LAND USE BOARD APPLICATION

Project:		PROPOSED RENOVATION & ADDITION 19 GRAVELLY POINT ROAD UNIT 19 HIGHLANDS LOT: 26.19 BLOCK: 100	
Owner:		MR. JOHN NASASI 19 GRAVELLY POINT ROAD HIGHLANDS NJ

Re: Completeness Review No. 1
Applicant: Nastasi
19 Gravelly Point Road
Block 100, Lot 26.19
Borough of Highlands, Monmouth County, New Jersey
Our File No.: HLPB24-04

Drawing Title:		LIL JOHN	
Project No.	2401	Date	1.18.24
CATHERINE FRANCO, AIA NJ RA A111411 NJ PP 5416		Drawn by:	CF
		Dwg. No.	Z1 1 of 3

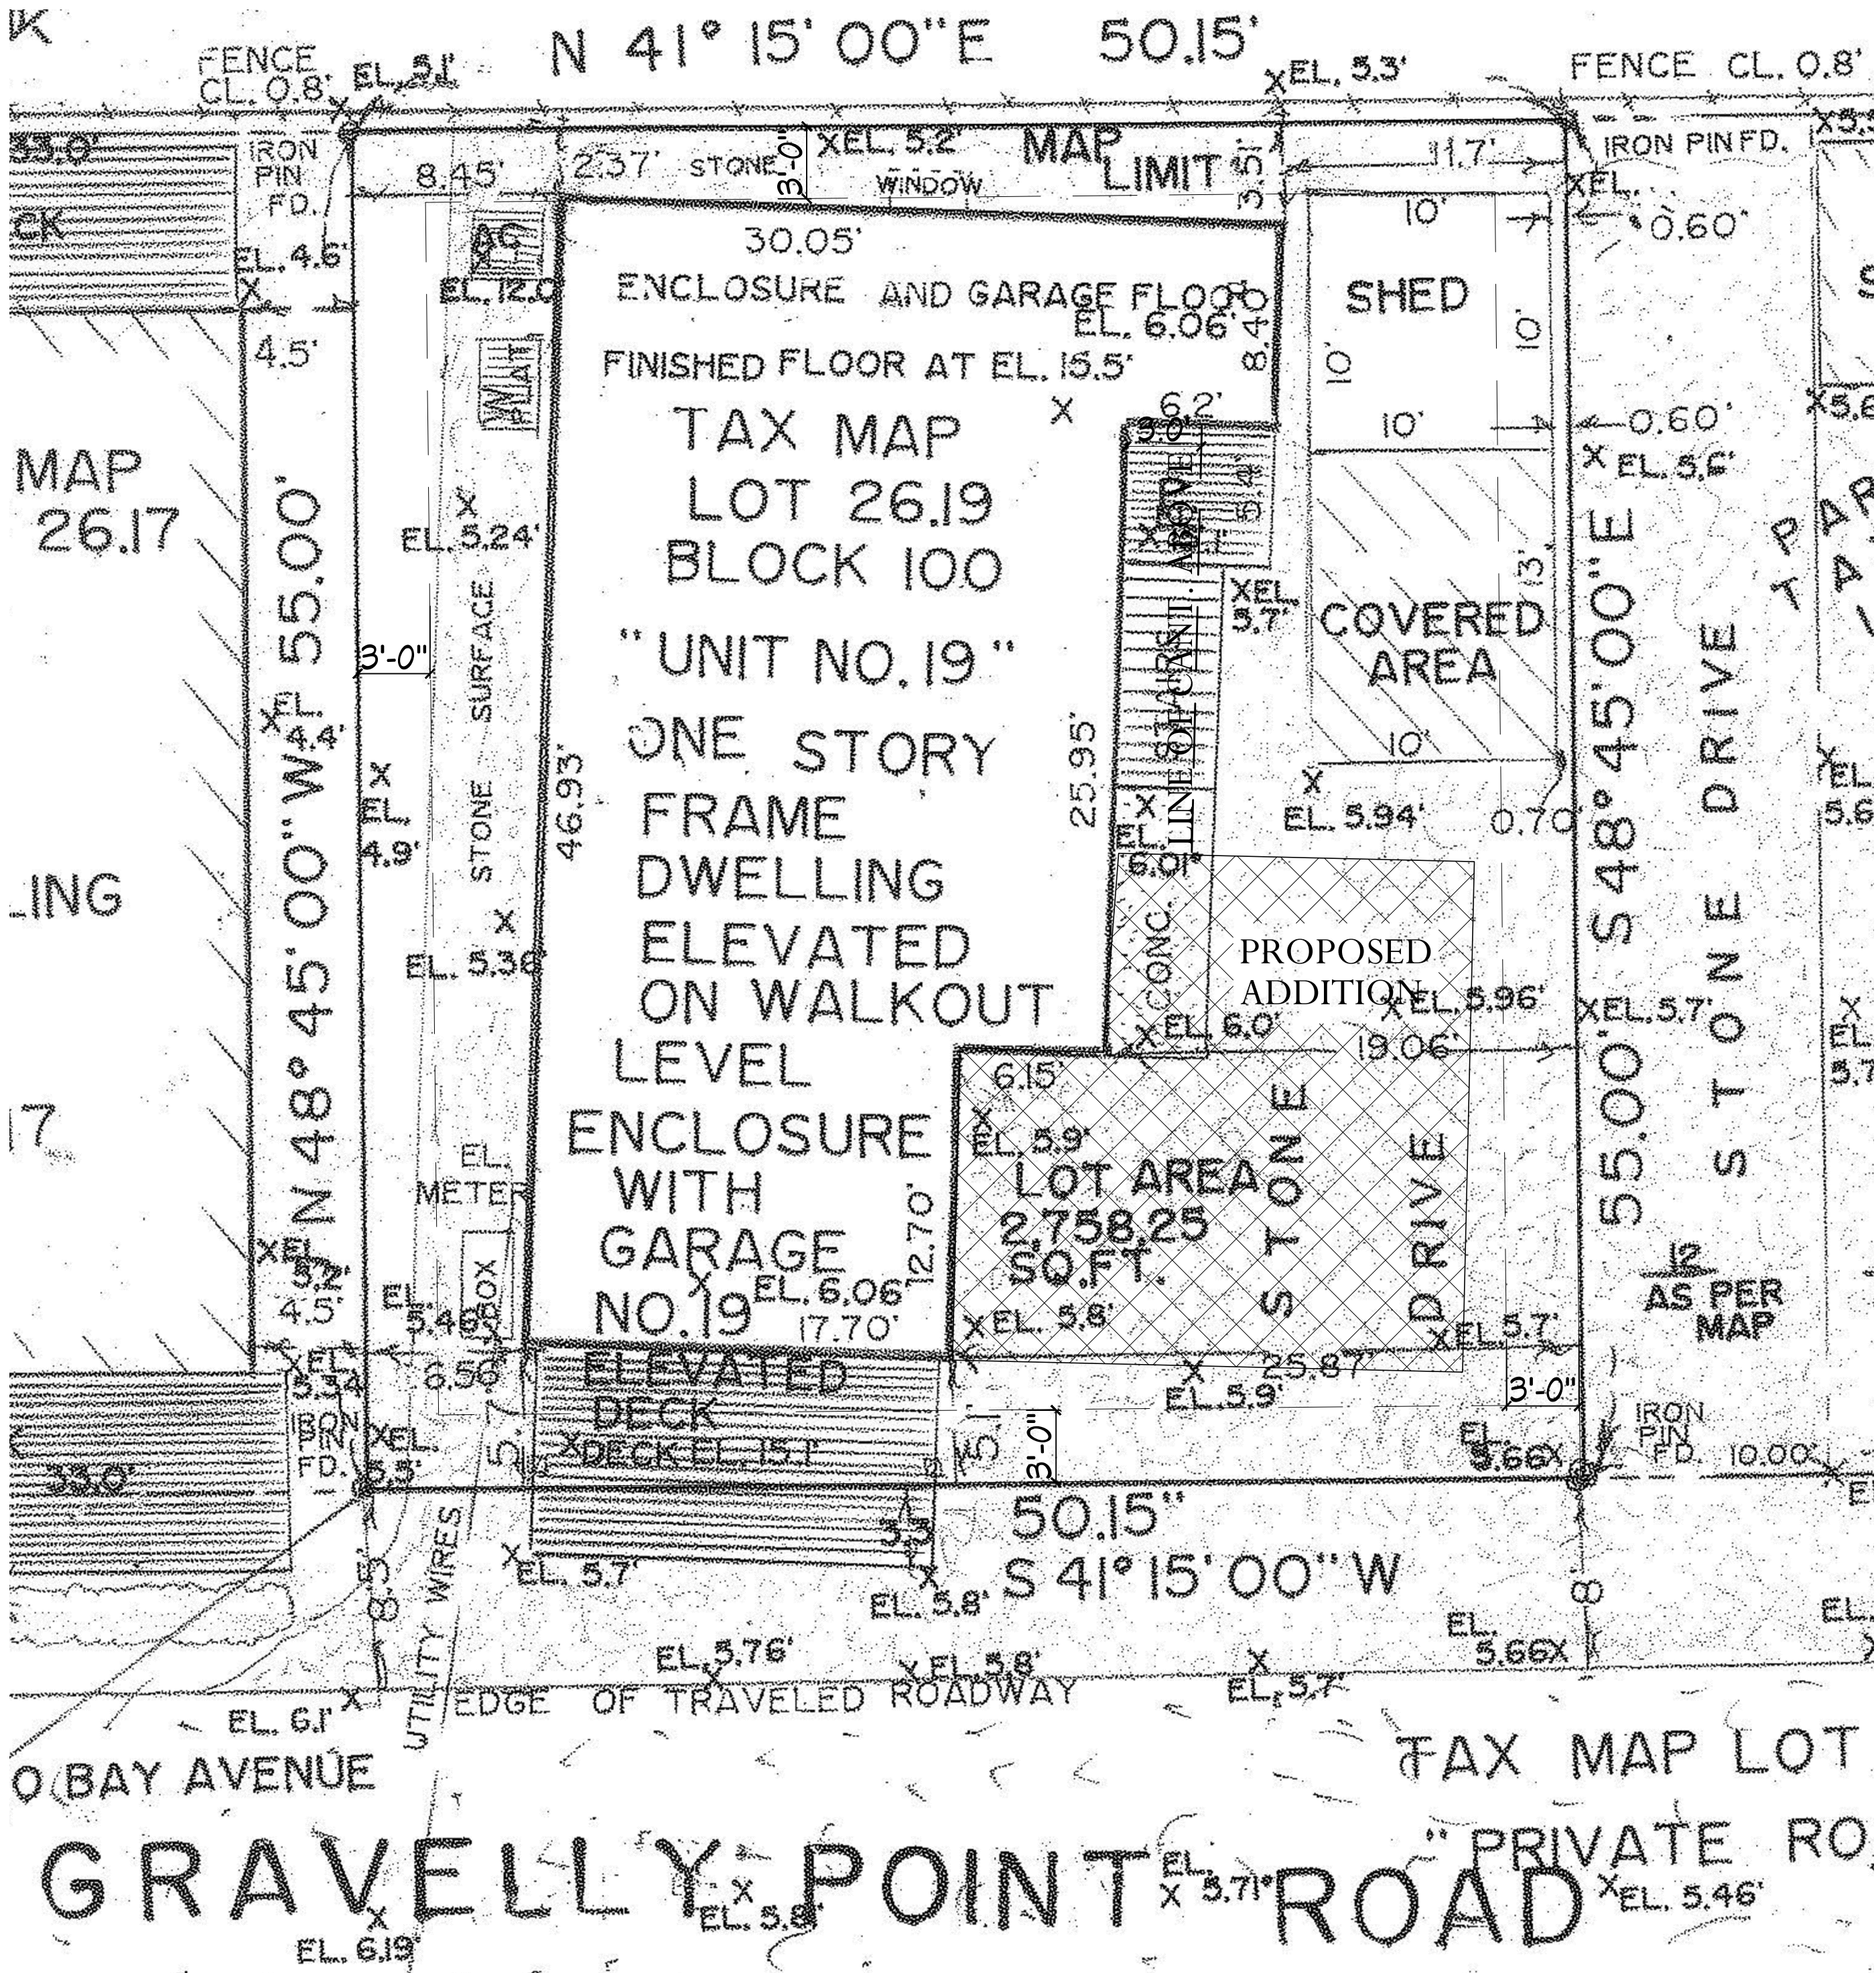
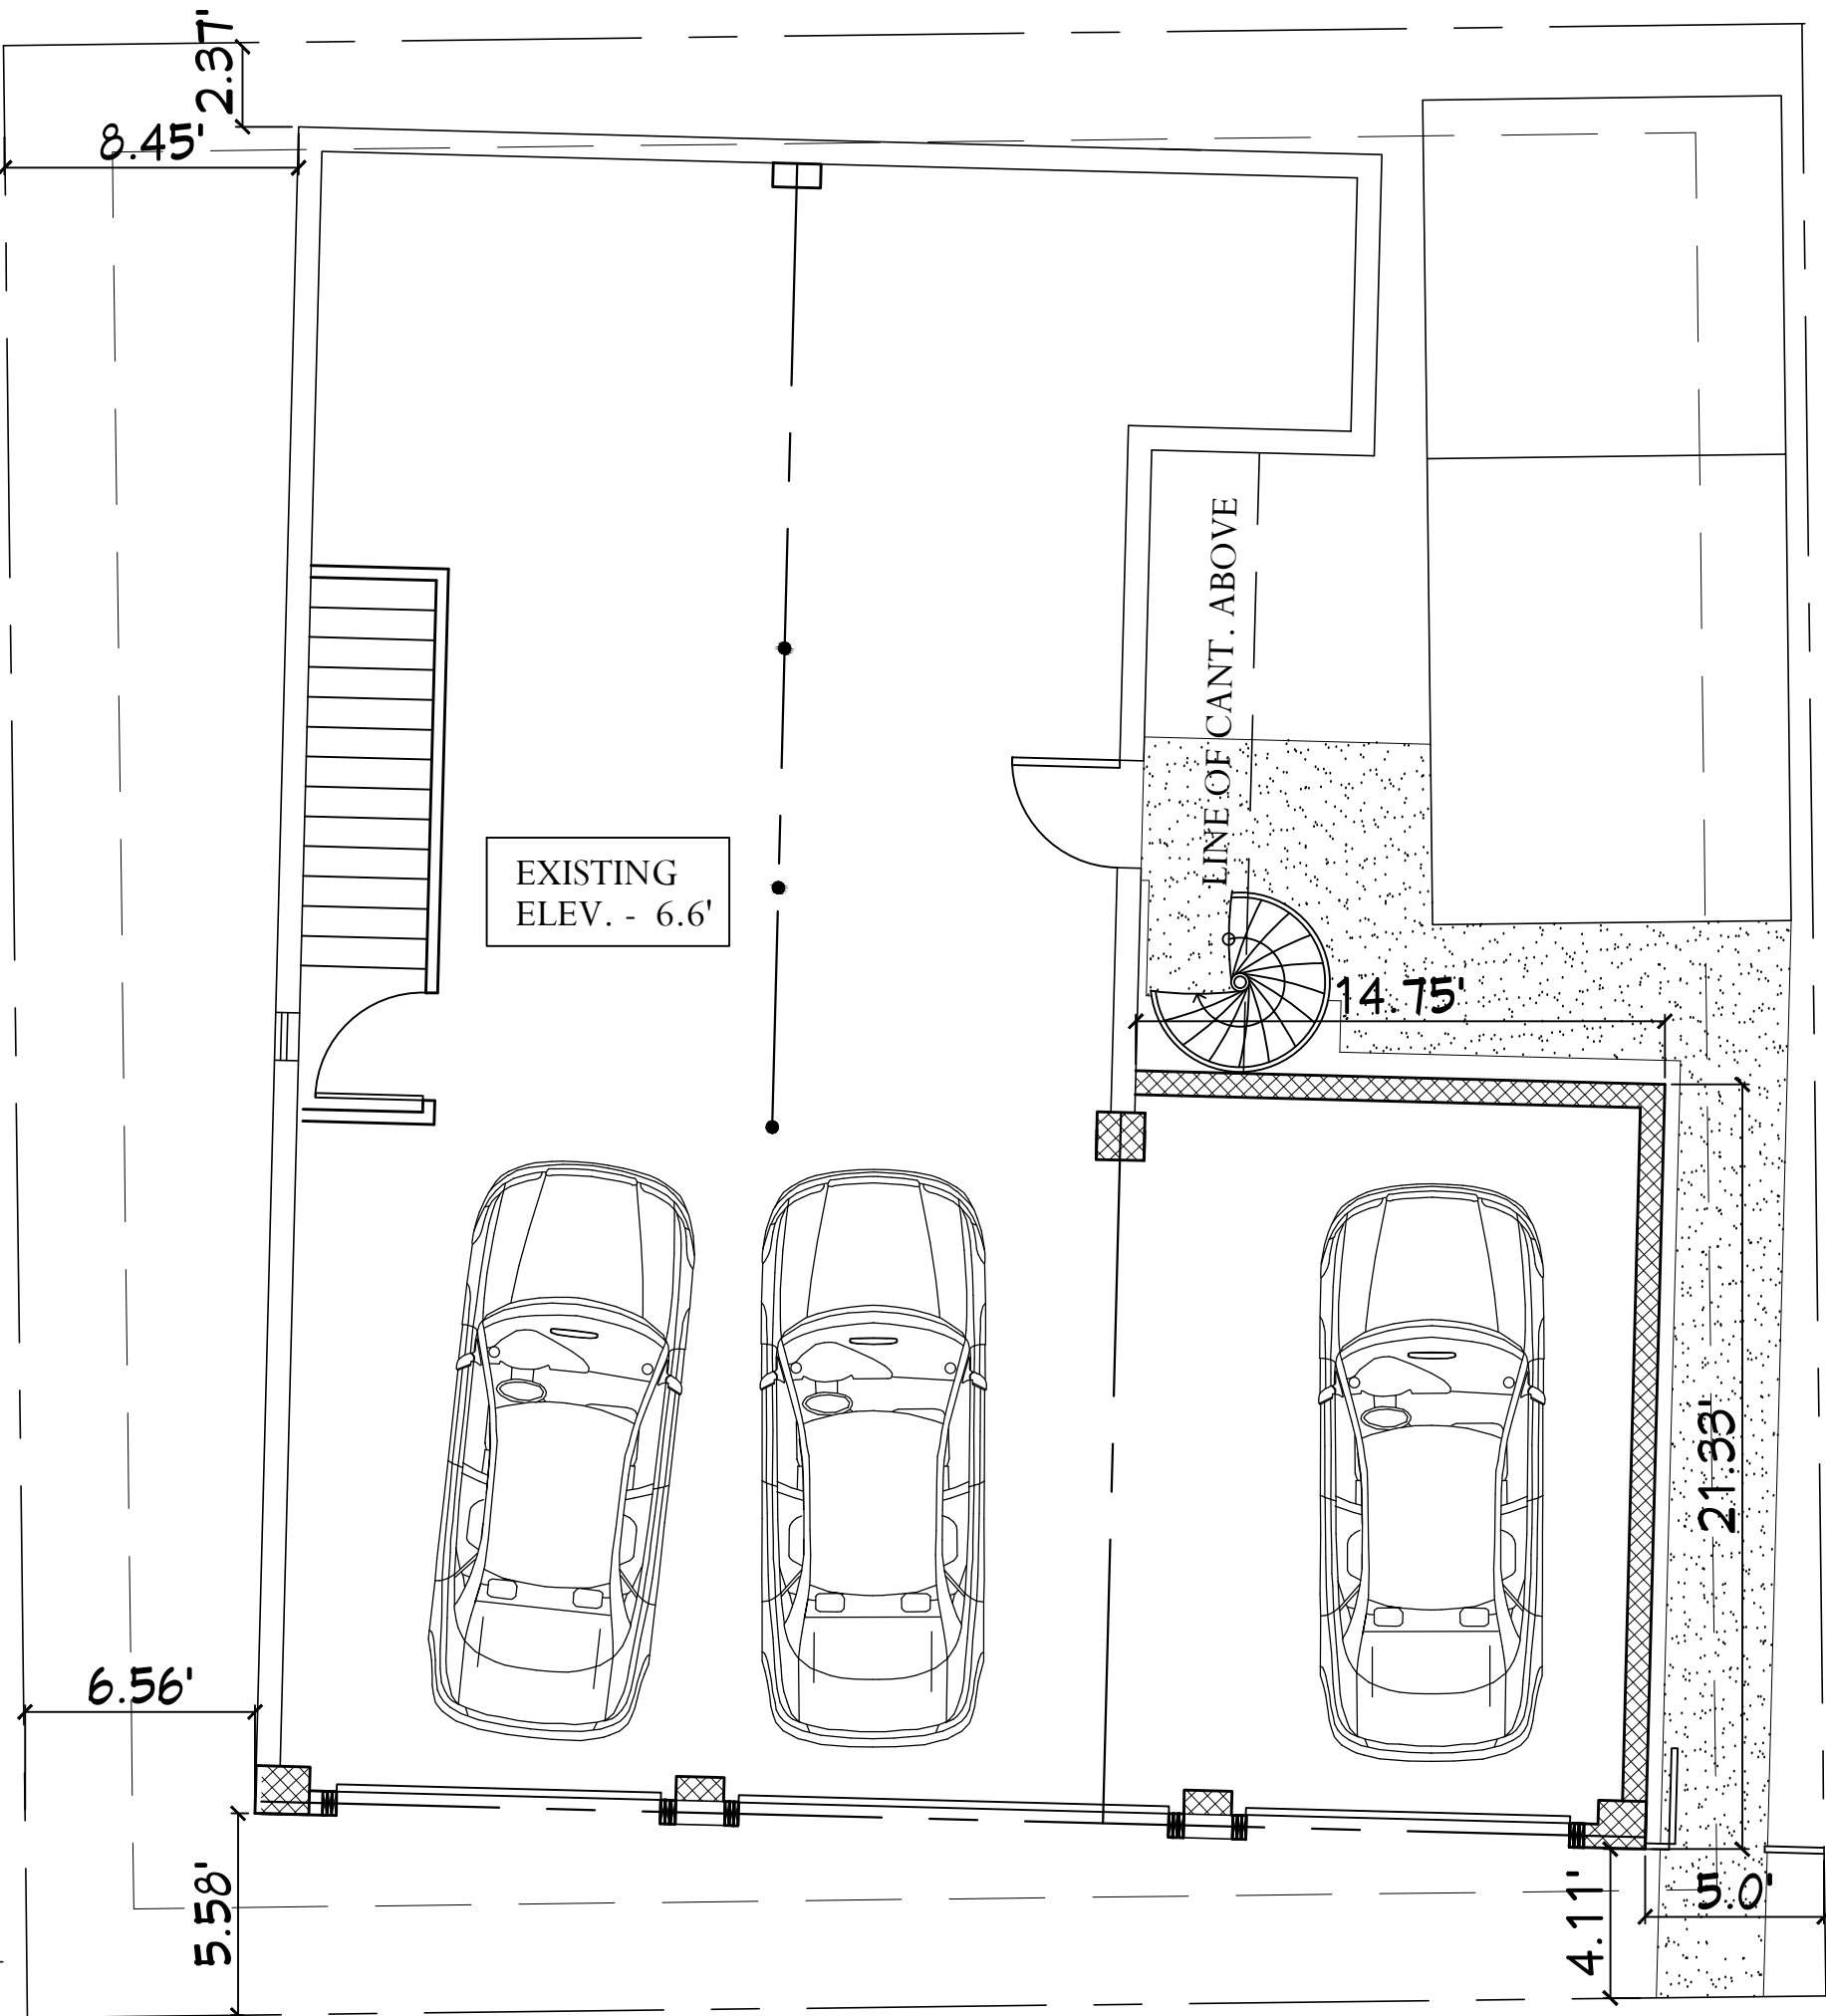
6. The existing garage elevation on the survey does not match the existing elevation shown on the site plan, Sheet 1 of 3. Please clarify if these elevations represent the pitch of the slab.
7. Please provide the base and design flood elevations and reference the FIRM panel on Sheet 1 of 3.
8. Please clarify the building height. There are different building heights noted in the documents.
